RESPONSES TO COMMENTS

UNITED STATES NUCLEAR REGULATORY COMMISSION COMMENTS REGARDING THE DRAFT FINAL SAMPLING AND ANALYSIS PLANS FOR THE REMEDIAL INVESTIGATIONS AT SPRING CREEK PARK AND DEAD HORSE BAY SITES GATEWAY NATIONAL RECREATION AREA, NEW YORK

Final

December 4, 2024

ATTACHMENT 2:
Maps Showing Example Gamma Survey Data Subsets from DHB

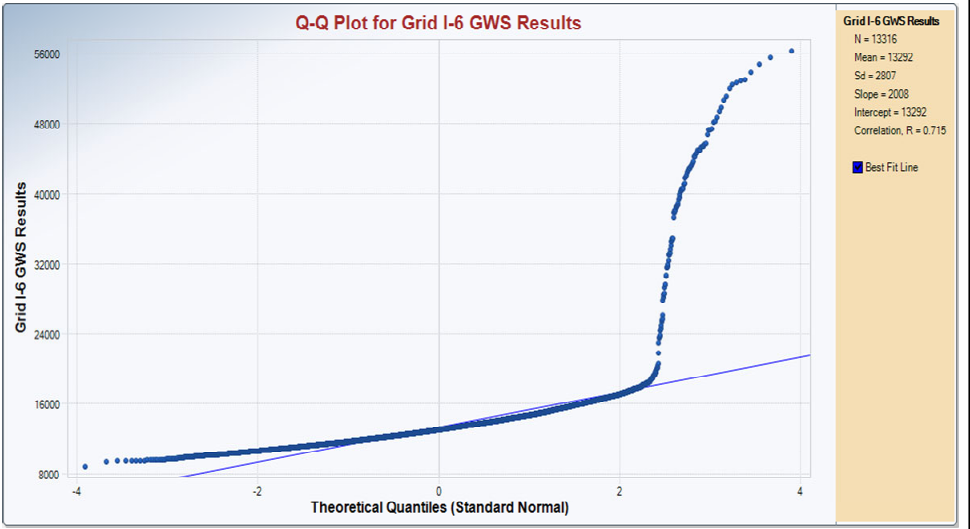
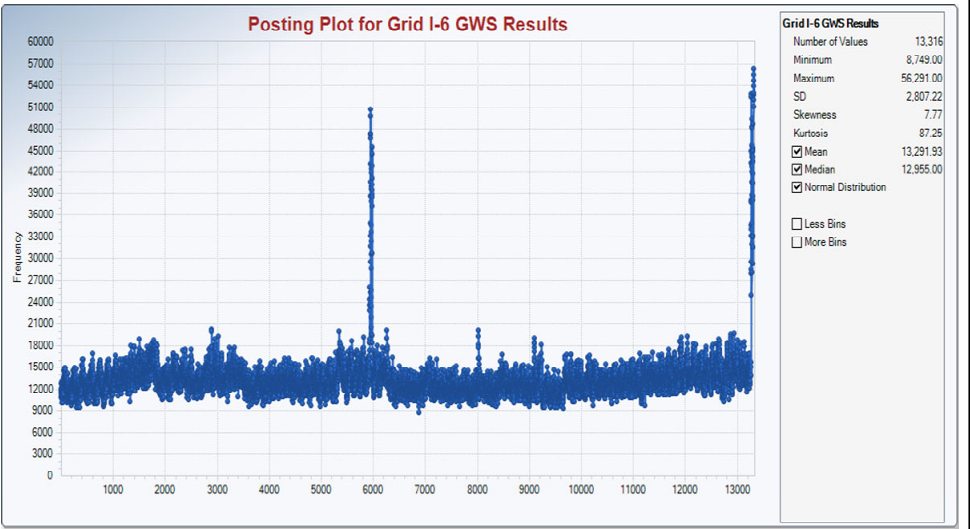
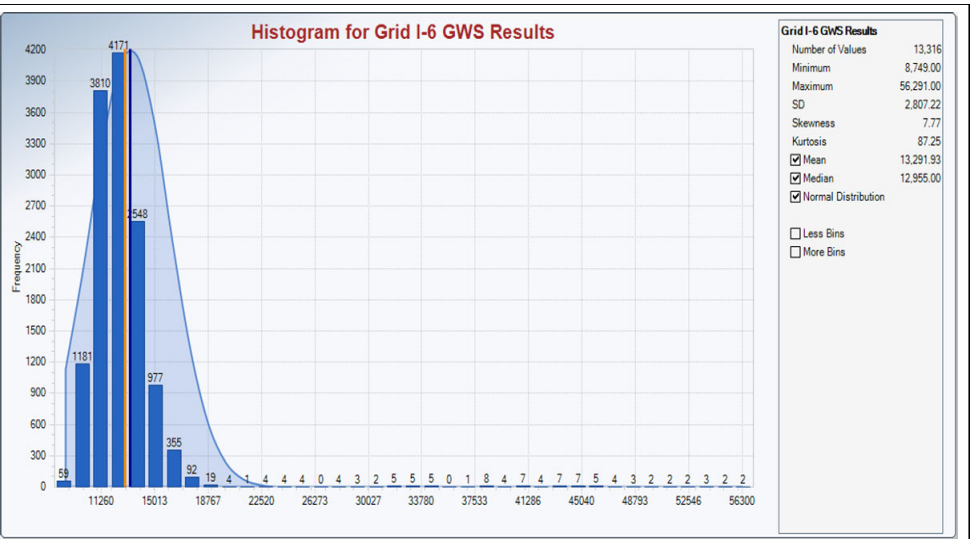
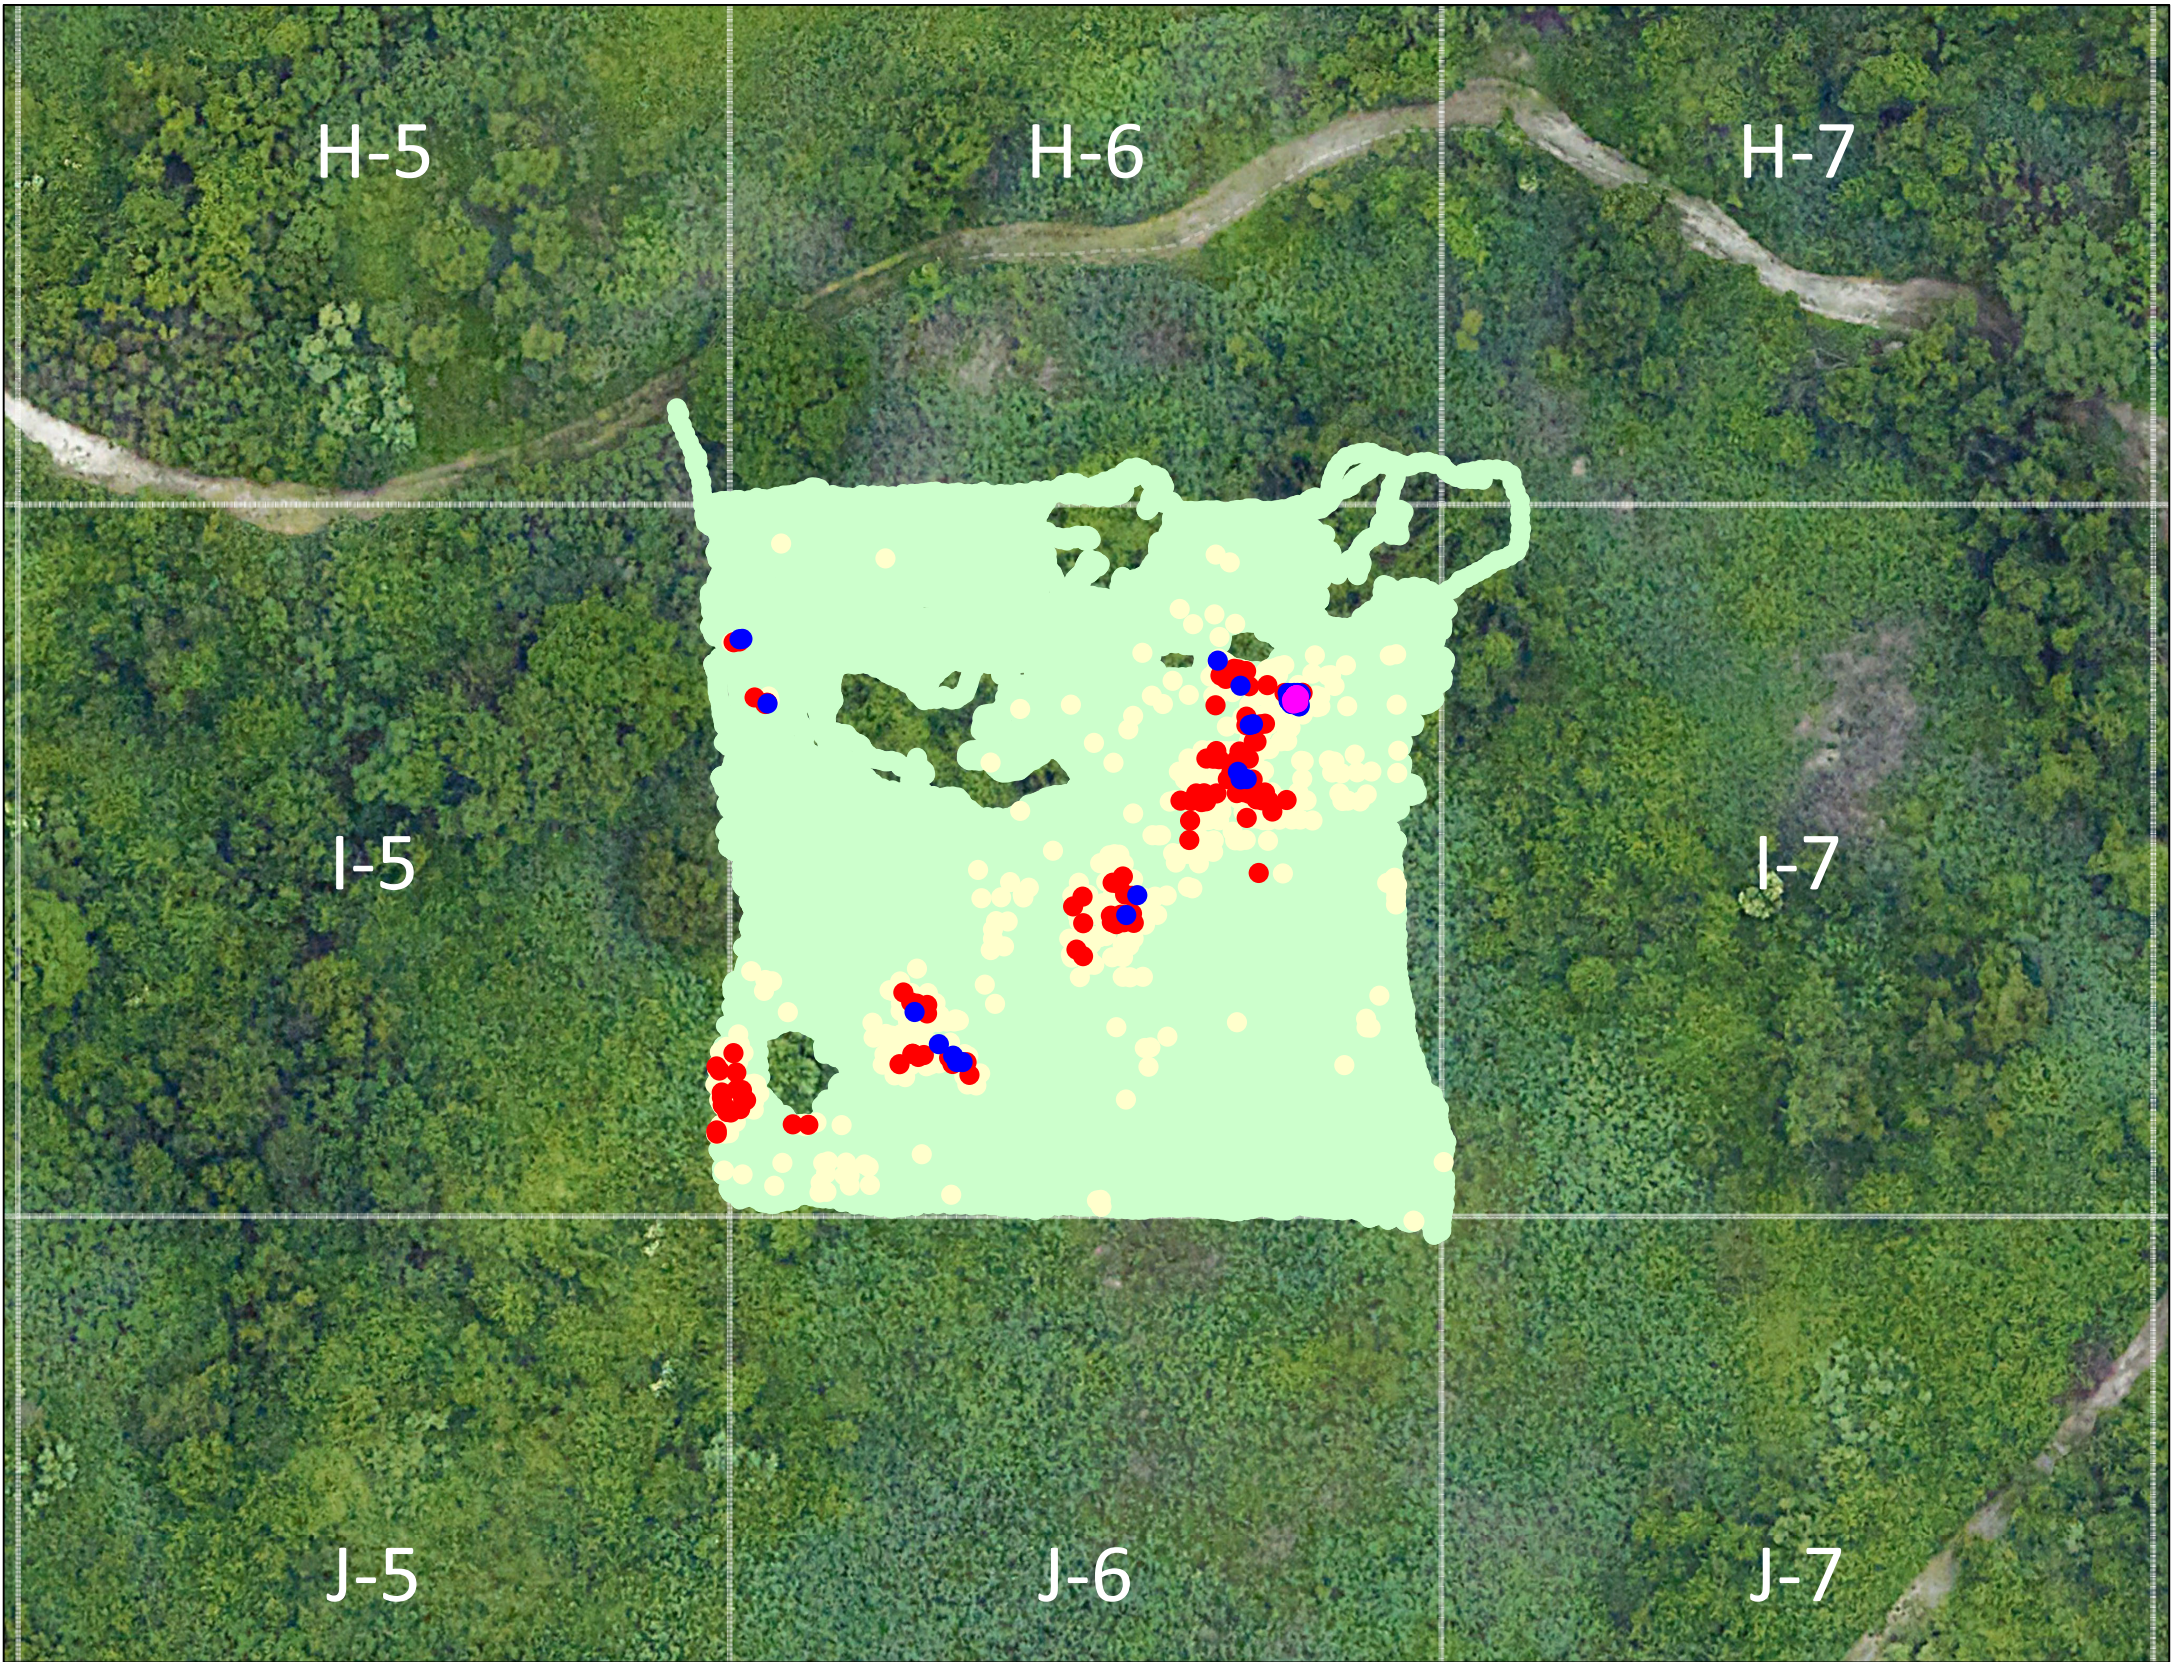
Comment 2: Investigation Level Statistics: The NRC staff recommends that the NPS describe the process for managing data to ensure the calculated z-score value will target the appropriate medium-specific response.

Description: In Section 5.5 of the SCP SAP, NPS states that a z-score greater than three will be considered indicative of contamination. Radiation survey planners often provide an investigation level that, when encountered, will prompt more detailed surveys and/or sampling. The goal is to limit false negative decisions (i.e., to limit the possibility of concluding that a medium is uncontaminated when, in fact, the medium is contaminated). Investigation levels have sometimes been established using historical precedence (i.e., NRC Regulatory Guide 1.86), industry guidance (e.g., per NUREG-1507), somewhat arbitrary guidelines (e.g., twice background), or other methods. The z-score approach is used at some sites, where a z-score is selected to represent a value sufficiently above the mean of the population to warrant additional consideration. For example, for a dataset with a normal distribution, over 99 percent of the results will fall below a measurement corresponding to a z-score = 3. An investigation level corresponding to z-score = 3

The presumption that contaminated environmental media can be surveyed and a distinct "background" detector response sample population obtained may be reasonable if the media is impacted, as purported by NPS, by discrete, or localized, contaminants such as man-made radiological articles. Further, assuming that each background response sample population is normally distributed, it is likely that the various environmental media will exhibit varying responses (e.g., the background response for monazite sands are likely to be significantly higher than fill material, clay, or other soil-like media). It is unclear to NRC staff whether the NPS plans to establish investigation levels for each media or from a site-wide population across all media.

NUREG-1507 describes how survey planners could erroneously group all survey data across different media or media with statistically different response distributions into a single population. As described in NUREG-1507, such errors can grossly overestimate the z-score value, thus increasing the potential for false negative decision errors. NPS should ensure that, if z-scores are used as investigation levels, the z-score value or values are based on medium- specific responses to avoid undermining the basis for the statistic and increasing the probability of false negative decision errors.

NPS Response: NPS understands and agrees with NRC's concerns regarding the Z-score approach described for evaluating gamma survey results and identifying radiological anomalies indicative of potential contamination. The SAPs present the simplest form of the Z-score evaluation in order to convey the general framework that will be used to evaluate the gamma survey data. In practice, NPS implements a more refined and rigorous data processing approach that involves: (1) evaluating gamma survey results in population subsets that are generally one acre in size or less to address the potential for variability in site media, (2) conducting statistical evaluations of each data subset using USEPA's ProUCL software (i.e., descriptive statistics to include evaluations of the kurtosis and skewness of the data subset, time-series data plots, quantile-quantile plots, and histograms) to ensure the subset population is appropriate for identifying contamination using a Z-score evaluation, (3) performing an iterative or modified Z-score approach to address high outliers (if necessary) that may bias the Z-score evaluation in a manner that could result in false negatives, and (4) mapping the resulting gamma survey data based on class-posted count rates, class-posted Z-scores, and contoured Z-scores to clearly map radiological anomalies using multiple approaches to ensure hotspots are not missed. **Attachment 2** presents figures of example data subsets from DHB to demonstrate how the gamma survey data were evaluated. NPS prefers to maintain the SAP in its current form in order to provide an appropriate amount of flexibility for evaluating the gamma survey results.
